**Final Acceptance Punchlist**  
**El Paso County – Department of Public Works - Stormwater Section**

Project Name:	The Gardens at North Carefree
EDARP Filing Number(s):	SF195, CON2012
ESQCP Number:	ESQ1912
Attendees:	DPW SW: Dylan Finley, Mikayla Hartford, Ben Jones DPW Development Services: Brad Walters, Joe Jackman, Spencer Pirzadeh, David Parkerson Developer: Grace Covington
Date of Walk-Thru:	02/01/2024
Walk-Thru Number:	1 <sup>st</sup>

Photo 1: North pond forebay not installed per spec. (Page 24 Forebay cross section)

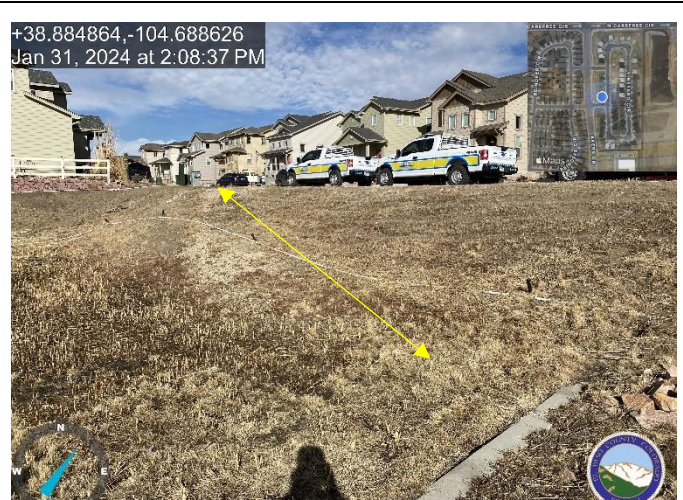
- **North Pond: (Page 24 of Construction Drawings)**
  - Pond forebay not installed per forebay cross section detail. Re-establish to pond details. Riprap to be installed per plan with a 12” drop between the top of the forebay curb and the riprap.
